SN J4630A-01

J4630A VQT Undercradle

Updated replacement of analog card for improved PESQ scores

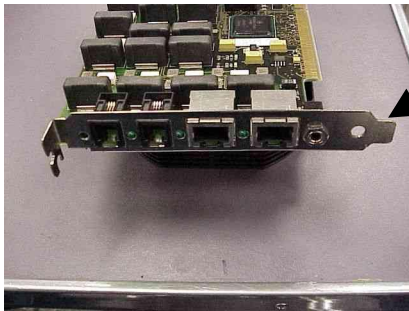
Adapting the Infineon ALIS FXO chipset for use in the E&M ports of the analog board results in extra circuit noise. This limits the maximum PESQ scores. Replacing this board with the modified assembly reduces the circuit noise and improves the possible PESQ scores when using the E&M ports .

Replace the analog FXO E&M card with the latest version. This, along with downloading the VQT application Software Version 4.1.1 or later. When the “defective” analog card is removed the metal grounding tab MUST be swapped to the new assembly.

Move metal tab to
new assembly.
